To: Independent Hearing Panel, Mackenzie District Plan Review, Phase 4

From: Richard Knott

Date: 9th June 2025

Re: Church of the Good Shepherd and the Statue of Sheepdog - Proposed Heritage Overlay

Figure 2: Plan showing the various viewpoints considered (prepared by RKL, based on aerial photo from Mackenzie e-plan)

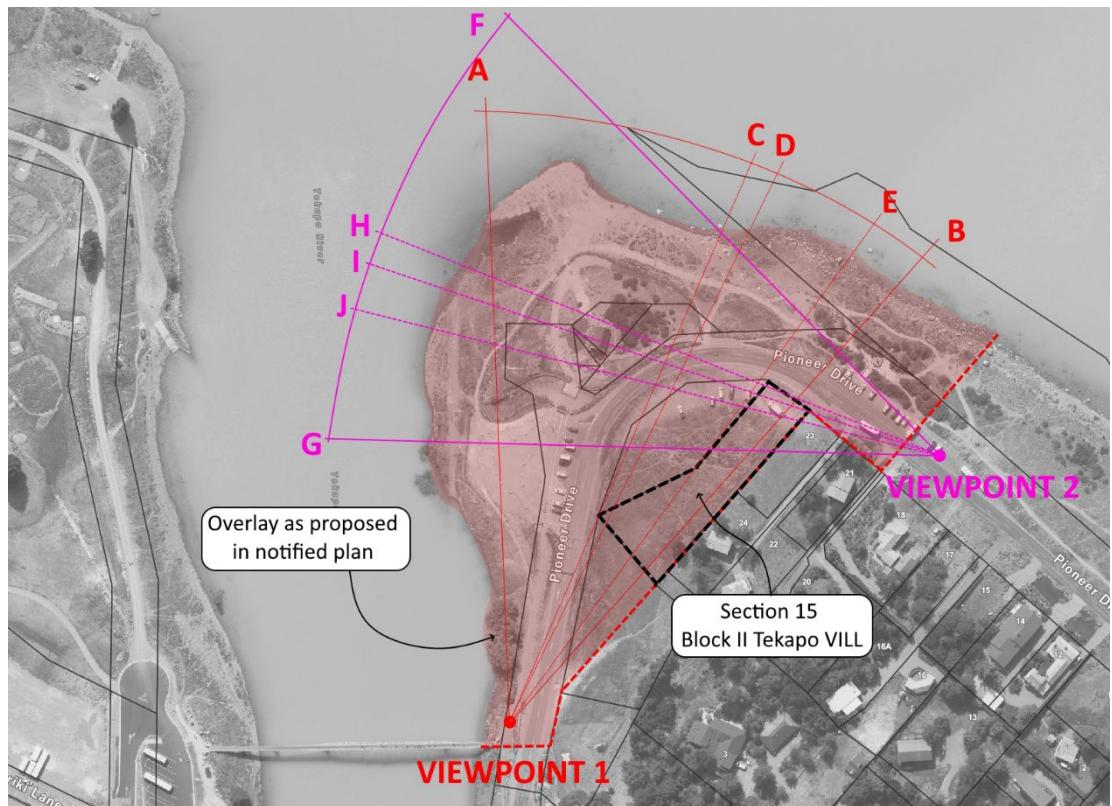
Viewpoint 1, A-B (complete photograph)

Viewpoint 2, F-G (complete photograph)

- 13 The complete horizontal area visible in each photograph (a 44.2 degree view – based upon the camera and lens combination used for the photographs, my recollection of where I stood when I took each photograph and key features visible in the photographs).
- 14 Having considered these views, I consider that it is not necessary for the whole of Area A shown on the photographs to be within the Overlay to provide the impression of openness and space around the Church and to ensure that it is viewed within a natural environment, and so maintain its heritage values i.e. a narrower view from these locations could achieve this.

Figure 3: Plan showing Viewpoint 1 and annotated photograph from Viewpoint 1 (photo RKL 4th March 2025, annotations added by RKL)

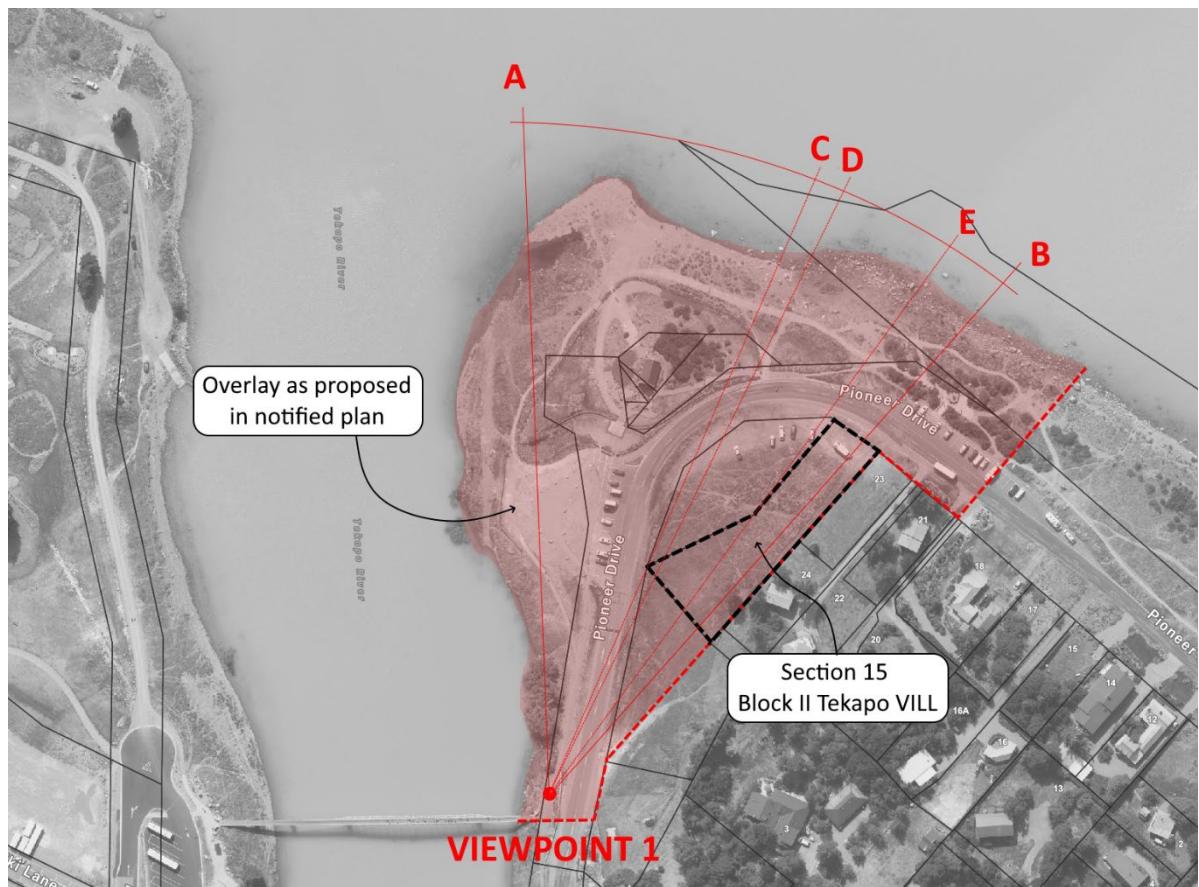
Viewpoint 1, A-C, excluding Section 15 from the Overlay

Viewpoint 1, A-D, excluding Section 15 from the Overlay and taking account of 4.5m front yard setback

- 15 On a clear day, the mountains are visible behind the lake in this view.
- 16 I consider that the construction of five buildings on Section 15, in line with the Low Density Residential Zone and subdivision standards, within the shaded area of these views (**D-B**) would be detrimental to the setting of the Church. They would take away from the impression of openness and space around the church and would be seen in the foreground of the wider natural environment, which currently makes a significant contribution to the heritage values of the Church.

- 17 I do not consider that maintaining only A-C or A-D free from development is sufficient to maintain the apparent openness around the Church or allow the Church to be viewed in the wider natural environment; the uninterrupted view of the Church and its backdrop would be too narrow.

- 18 From Viewpoint 1, I do not consider that removing Section 15 from the Overlay would lead to an outcome which would maintain the heritage values of the Church, whether or not account is taken on the required front boundary setback.

Figure 4: Plan showing Viewpoint 2 and annotated photograph from Viewpoint 2 (photo RKL 4th March 2025, annotations added by RKL)

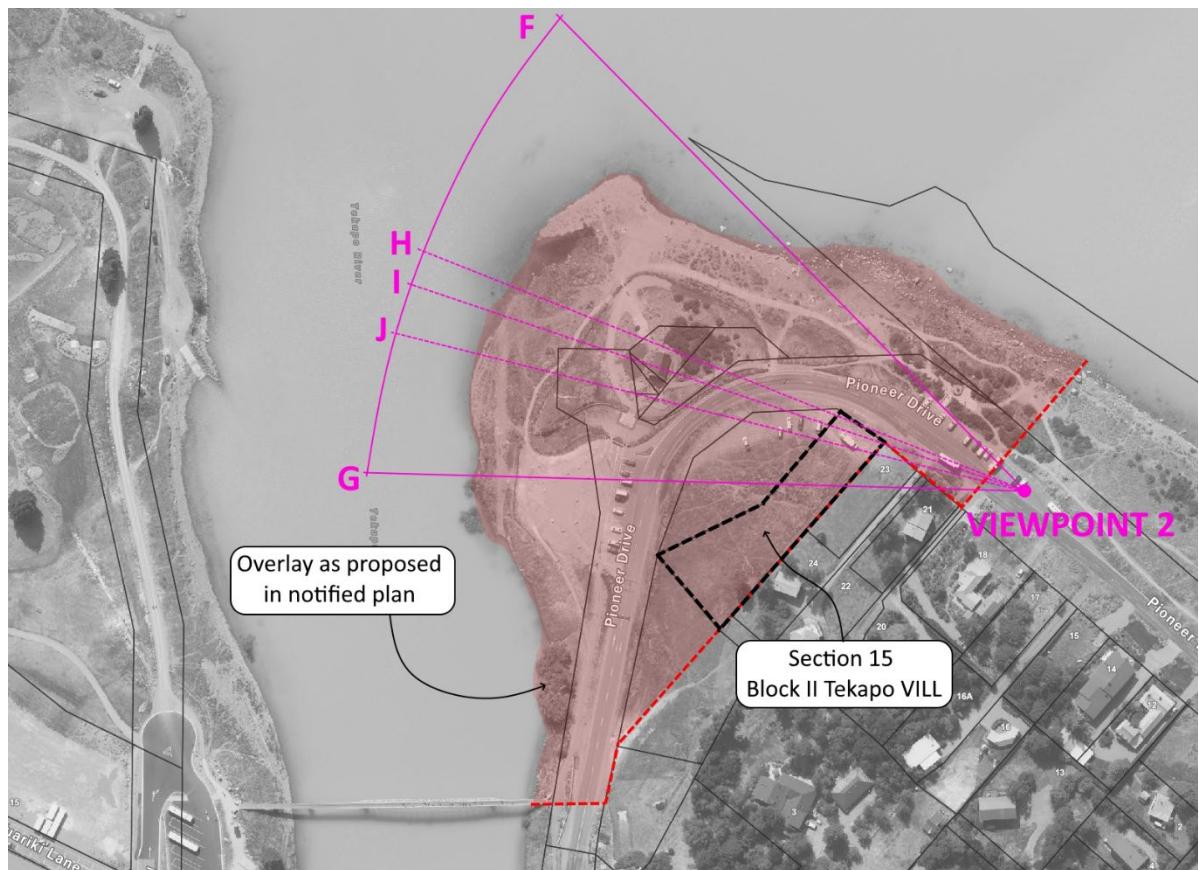
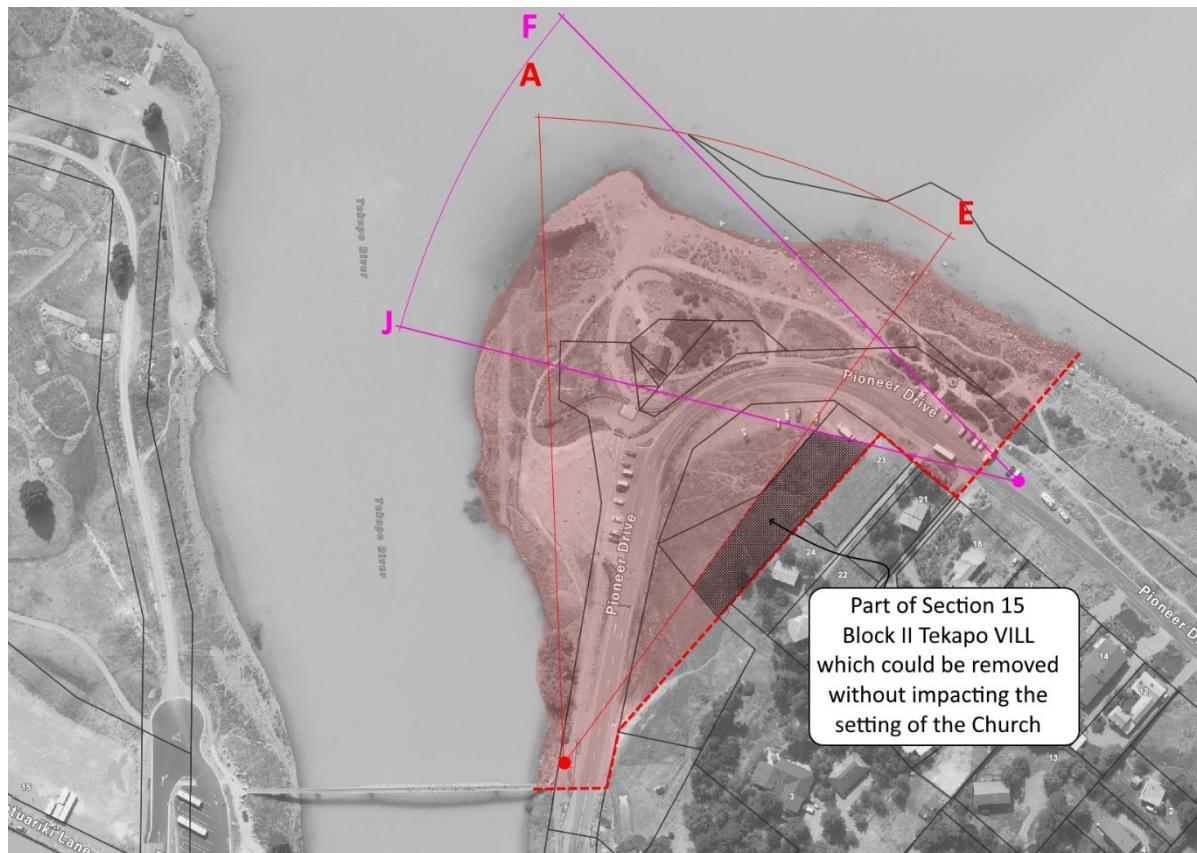
Viewpoint 2, F-H, excluding Section 15 Block II Tekapo VILL from the Overlay

Viewpoint 2, F-I, excluding Section 15 Block II Tekapo VILL from the Overlay and taking account of 4.5m front yard setback

- 19 Removing Section 15 from the Overlay would allow buildings to be developed on the land in line with the Low Density Residential Zone and subdivision standards. These buildings would be viewed immediately in front of the Church (or in the case of F-I, they would overlap views of the Church).
- 20 This would impact the impression of space and openness around the Church.
- 21 From Viewpoint 2, I do not consider that removing Section 15 from the Overlay would lead to an outcome which would

maintain the heritage values of the Church, whether or not account is taken on the required front boundary setback.
